DEVIATION REQUEST AND DECISION FORM

Project Name : Urban Collection at Palmer Village
Schedule No.(s) : 5405100041, 5405100042, 5405100043, and 5405100044
Legal Description : See Attachment #1

A deviation from the standards of or in Section **Section 2.3.7.F.1 Curb Returns – Radii, Table 2-31** of the Engineering Criteria Manual (ECM) is requested.

PUD DEVELOPMENT/PRELIMINARY PLAN

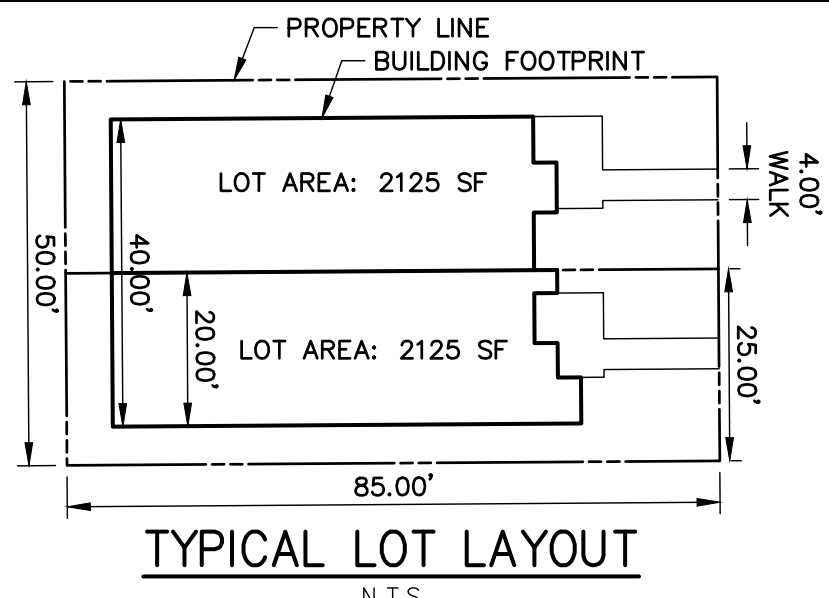
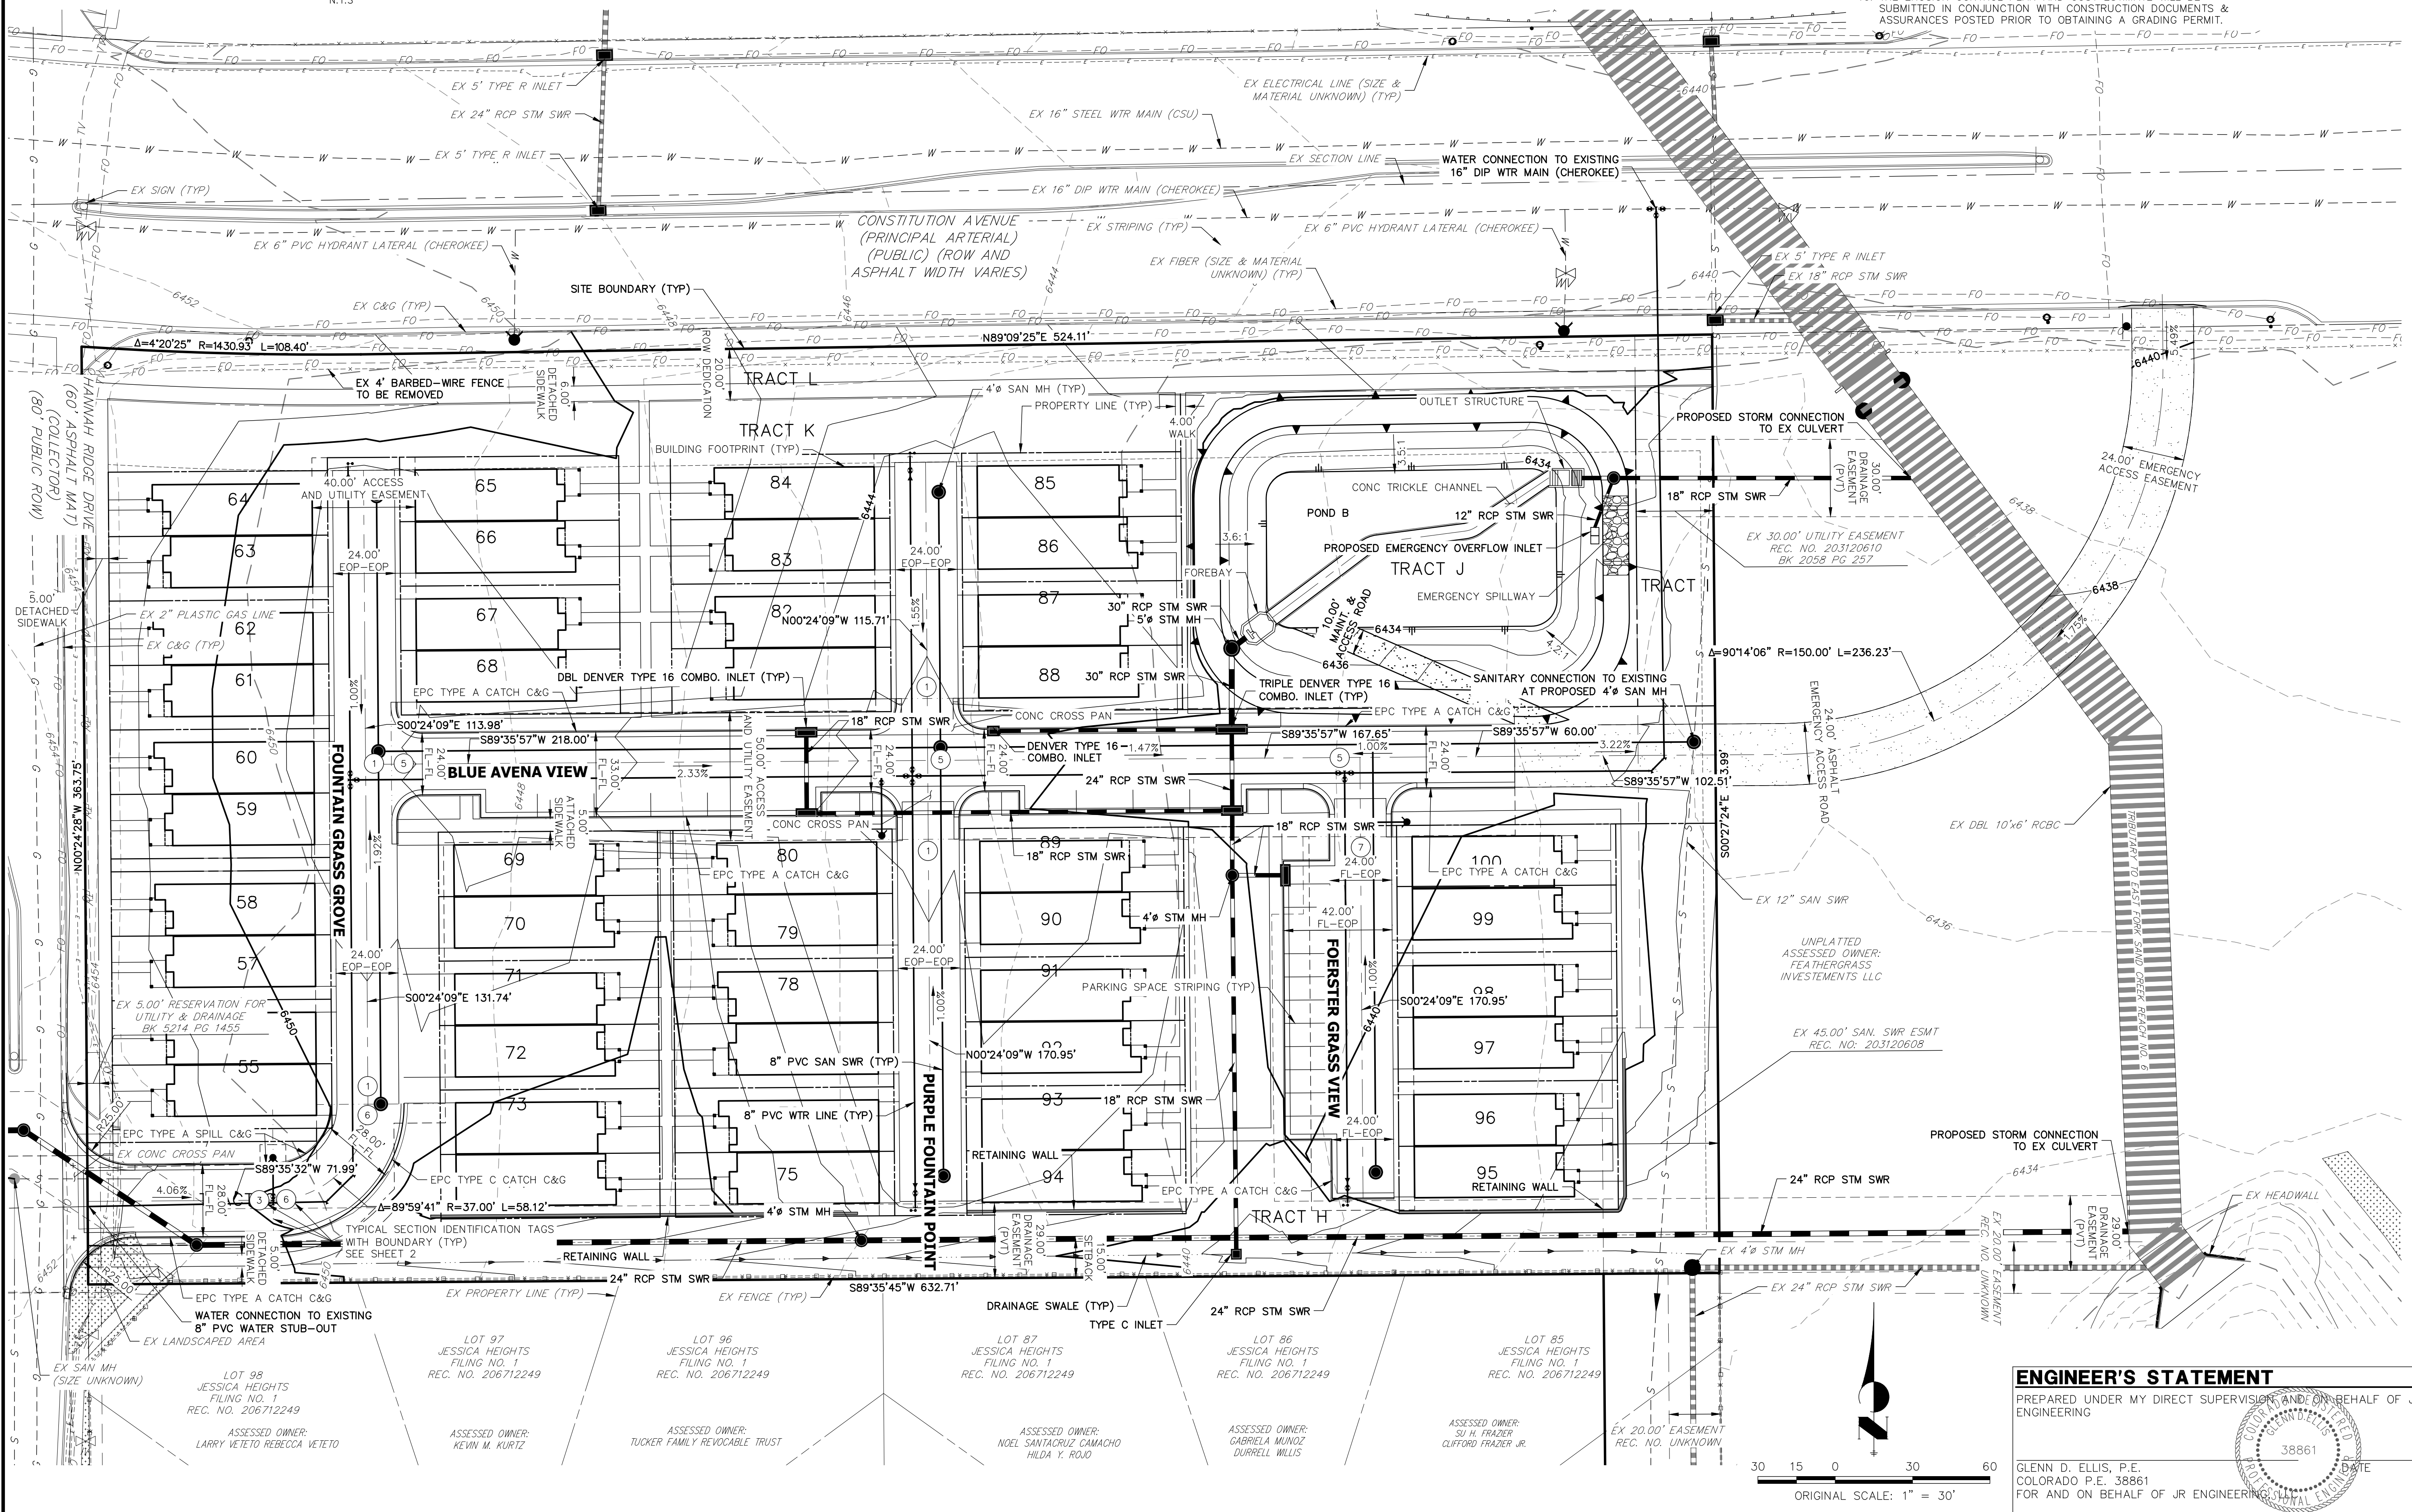
This request is to utilize a minimum of 10' curb return radii throughout the development. The request is to better facilitate the site layout while allowing designated parking areas to meet requirements. See the Preliminary Plan in Attachment #2 for a layout of the development. The County criteria does not address alley/alley intersections, or any type of intersection with an alley.

The entrances to the alleys (private) and along the main road (private) will have curb return radii of 10' instead of 20'.

AUTOTURN FIRE TRUCK
EXHIBIT – WEST SIDE
PALMER VILLAGE
JOB NO. 25149.01
04/20/2020
SHEET 1 OF 3

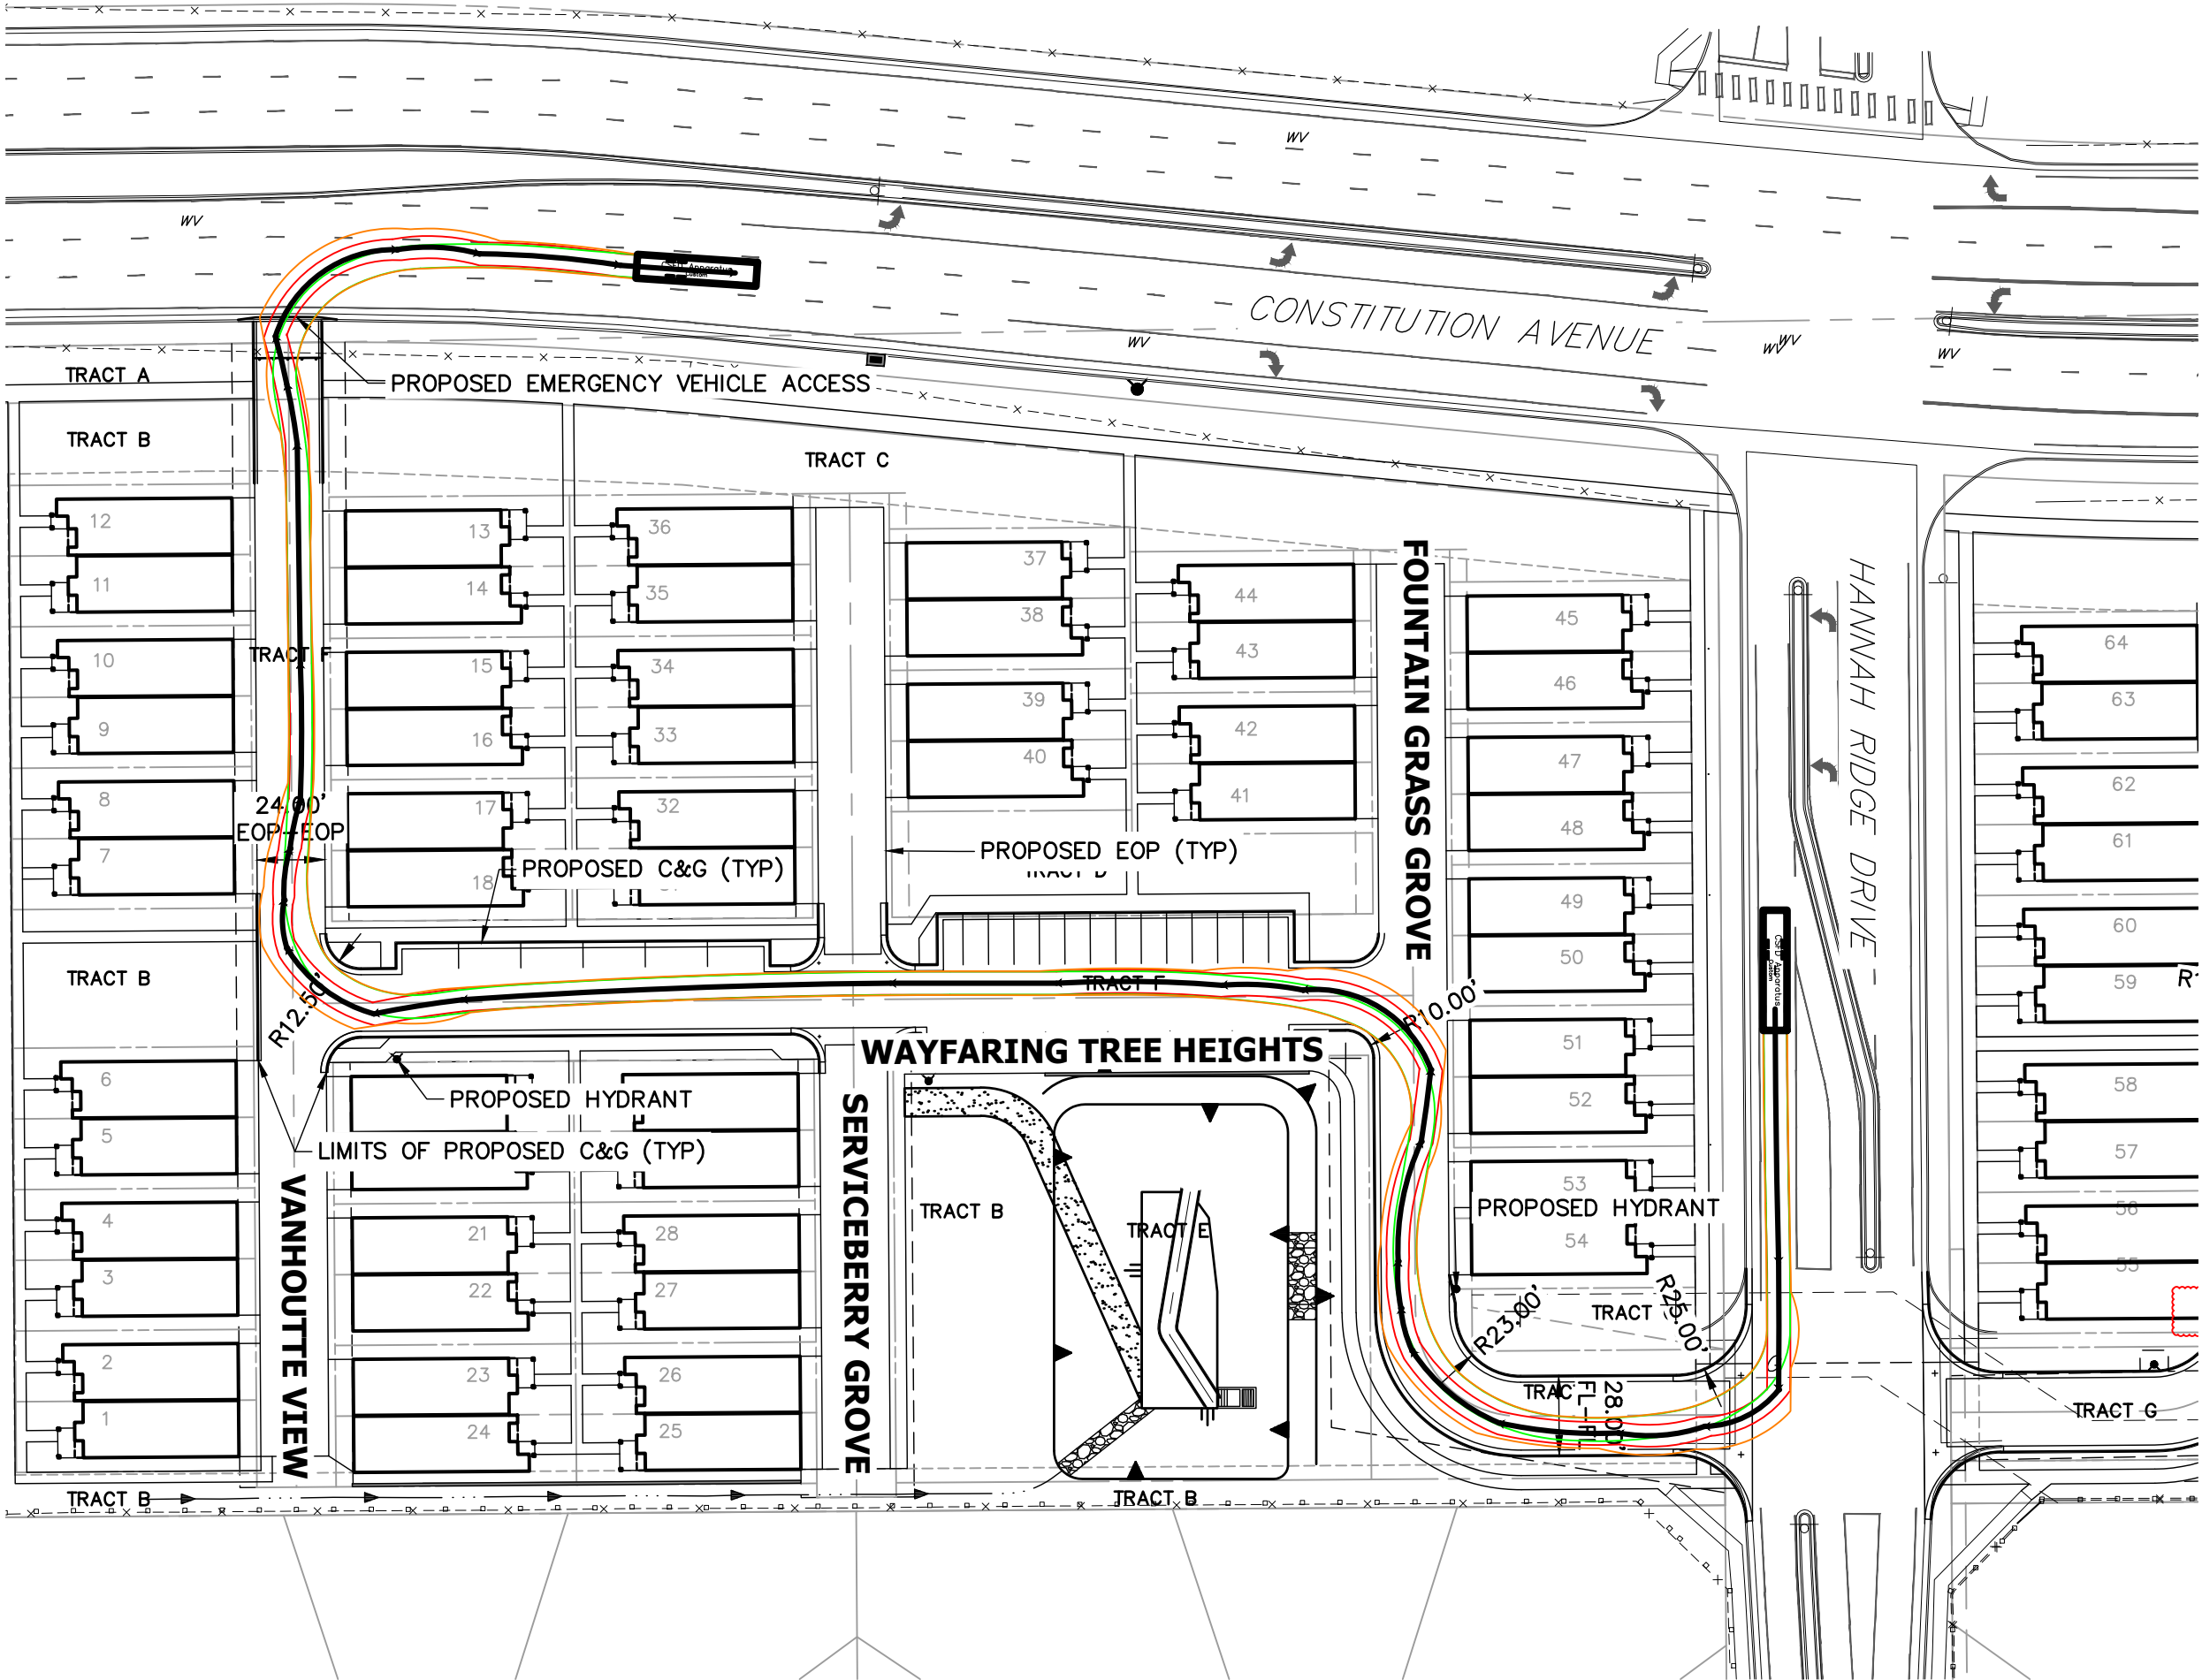
The private roadway network of the development will function and be laid out as alleys off of Hannah Ridge Drive. The County criteria does not address alleys. The development requires parking for the units to be along the roadway, therefore the tighter radii will facilitate maximizing available parking areas. Turning templates have been evaluated for fire and trash trucks. These are shown in Attachment 3.

Access into the alleys (private), and through the intersections will not be impeded by the reduced curb return radii. Turning templates have been evaluated for fire and trash trucks. These are shown in Attachment 3.

The reduced curb return radii will not adversely affect safety or operation. The reduced radii will facilitate slower speeds and require increased awareness by motorists entering or leaving an intersection (alley). Turning templates have been evaluated for fire and trash trucks. These are shown in Attachment 3.
